Access Compliance Report

Public Rights-of-Way

Intersection ID: 28045	Main Street: PROVIDENCE_COUNTRY_CLUB_DR	Cross Street: ROYAL_PORTRUSH_DR	Location: S
ADA ID: 920DD3D6C1D4	Ramp Type: BlendTrans1	Initial Pass/Fail: Fail	Overall Compliance: No
Codes/Mitigation Info/Possible Solution		Field Measurements/Component Compliance	
Severity Score: 1.25

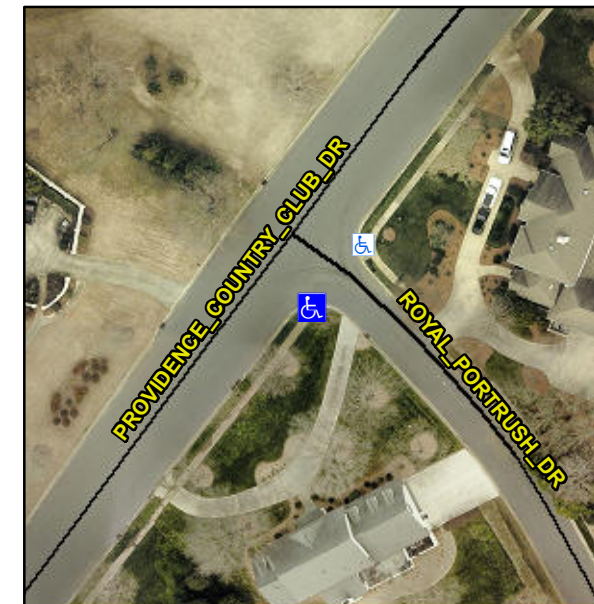
Not Found, R304.5.3

Compliance	Description	Data	Compliance	Description	Data
N/A	Ramp Length (in)	55.0	Yes	BlendTrans Slope (%)	4.0
Yes	Ramp Width (in)	48.0	No	BlendTrans XSlope (%)	3.6
N/A	Flare Type LT	N/A	N/A	Flare Type RT	N/A
N/A	Flare Slope LT (%)	N/A	N/A	Flare Slope RT (%)	N/A
N/A	Flare Traversable LT?	N/A	N/A	Flare Traversable RT?	N/A
N/A	Landing Length (in)	N/A	N/A	DWS Provided?	N/A
N/A	Landing Width (in)	N/A	N/A	DWS Contrast?	N/A
N/A	Landing Slope (%)	N/A	N/A	DWS Length (in)	N/A
N/A	Landing X Slope (%)	N/A	N/A	DWS Full Width?	N/A
N/A	Landing Curb? (Y/N)	N/A	N/A	DWS Offset (in)	N/A
N/A	Shared Landing?	N/A			
N/A	Gutter Ponding?	N/A	N/A	Gutter Slope (%)	N/A
N/A	Gutter Lip Ht (in)	N/A	N/A	Gutter X Slope (%)	N/A
N/A	Painted X Walk1?	No	N/A	Painted X Walk2?	N/A
	X Walk 1 Direction	To NE		X Walk 2 Direction	N/A
	X Walk 1 Width (in)	N/A		X Walk 2 Width (in)	N/A
	X Walk 1 Slope (%)	2.2		X Walk 2 Slope (%)	N/A
	X Walk 1 X Slope (%)	4.1		X Walk 2 X Slope (%)	N/A

N/A	Ramp inside XWalk1?	N/A	N/A	Ramp inside XWalk2?	N/A
	Road Slope (%)	4.1		Clear Space?	N/A
	Road X Slope (%)	2.2	N/A	Clear Space to XWalk (in)	N/A
N/A	Any Obstructions?	N/A	N/A	Storm Grate/Utility Hazard?	N/A
	Obstruction Type			Storm Grate/Utility Type	
		N/A			N/A
			Yes	Surface Condition? (G/P)	Good
			No	Curb Slope (%)	17.0

Remove & Replace Curb Ramp With Two New Directional Ramps or Equivalent.
